CITY OF ALBUQUERQUE

**RE: Legacy NAA Apartments-Building 17
6301 Alameda
Requested for Permanent C. O. – Not Accepted
Engineers Stamp Date 9/15/16 (C18D064B)
Certification dated: 11-18-19**

GRADING AND
DRAINAGE PLAN

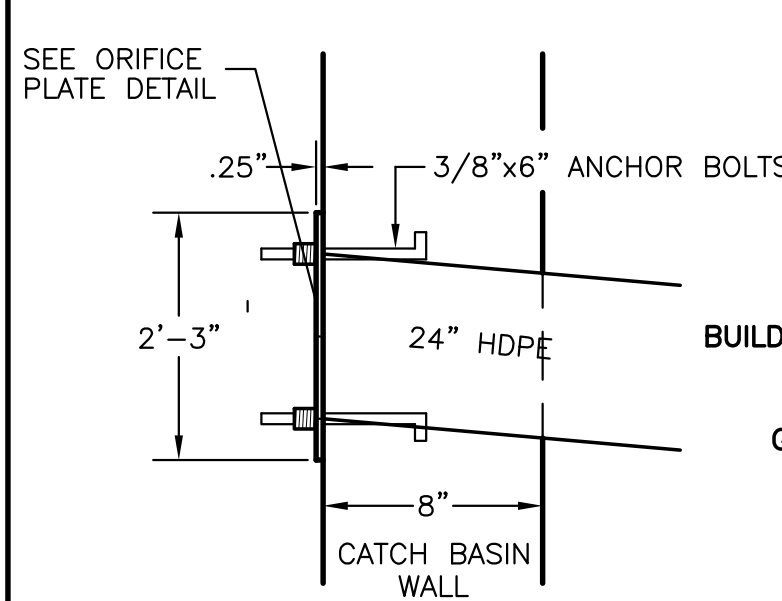
- Water quality pond west of pool house is missing.
- Two 6" PVC pipes missing under sidewalk south end of pool.
